Product Discontinuation Notices

No. 2011E018

Discontinuation Notice of Solid State Relay G3NH series

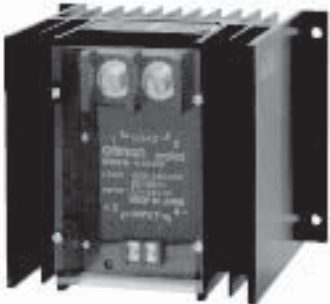
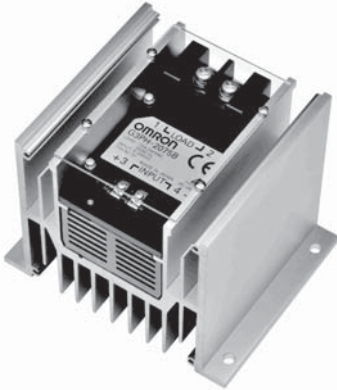
- Change of heat-sink color
- Change of LED (Indicator) color and LED position
- Change of power device (Thyristor module) for maintenance use.
- Recommended replacement model G3PH is now under developing. Plan to release in August /2011.

Body color

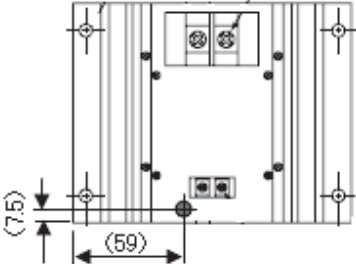
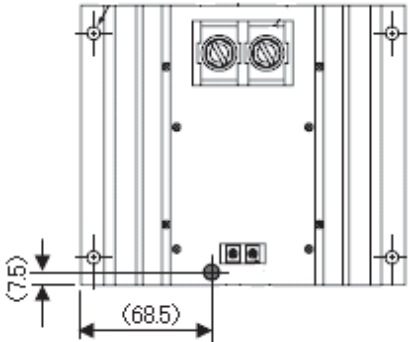
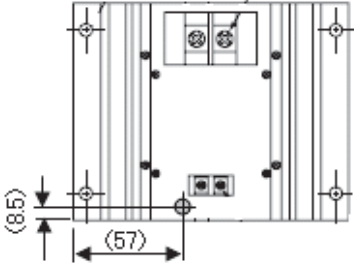
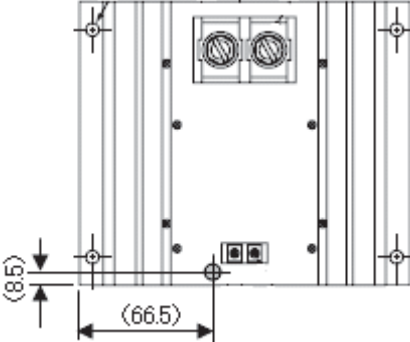
Product discontinuation G3NH	Recommendable replacement G3PH
<p>Heat -sink color : Black</p> 	<p>Heat -sink color : Silver</p>

Product discontinuation G3NH	Recommendable replacement G3PH
<p>LED color Red</p> <p>LED position G3NH-2075B, G3NH-4075B</p>  <p>G3NH-2150B, G3NH-4150B</p> 	<p>LED color Orange</p> <p>LED position G3PH-2075B, G3PH-5075B</p>  <p>G3PH-2150B, G3PH-5150B</p>
